**From:** Mess, Camie  
**Sent:** Friday, July 21, 2017 10:35 AM  
**To:** 'gjackmail@gmail.com'  
**Subject:** BAR Action - 416-418 West Main Street - July 18, 2017

**Re: Certificate of Appropriateness Application**  
BAR 17-06-09  
416-418 West Main Street  
Tax Parcel 290012000  
Main Street West, LLC, Owner/ Greg Jackson, Applicant  
Roof Addition

**CITY OF CHARLOTTESVILLE  
BOARD OF ARCHITECTURAL REVIEW  
STAFF REPORT  
July 18, 2017**

Roof Addition

416-418 W. MAIN ST.	ELEVATION & ROOF	<b>PROPOSED</b>	TOPIA design	6.27.2017	15/16
---------------------	------------------	-----------------	--------------	-----------	-------

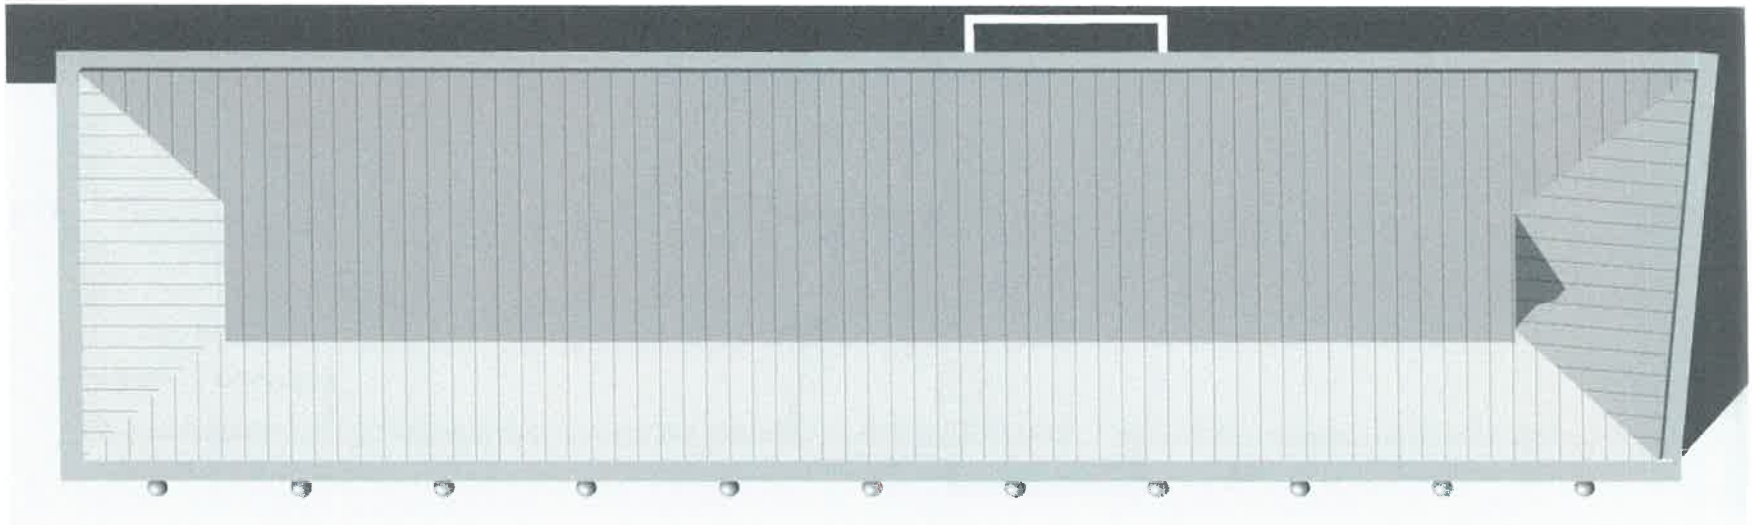
**Balut moved: Having considered the standards set forth within the City Code, including City Design Guidelines for New Construction and Additions, I move to find that the proposed new roof addition satisfies the BAR's criteria and guidelines and is compatible with this property and other properties in the Downtown ADC district, and that the BAR approves the application, with the stipulation that the applicant submit color renderings of the proposed design in the most realistic possible fashion, for the BAR to review and approve [to be circulated via e-mail], prior to the COA being issued. [The BAR recommends a darker color for than the light grey.] Graves seconded. Motion approved (4-2, with Gastinger and Schwarz opposed).**

The lower roof profile is an improvement and the materials and colors are appropriate.
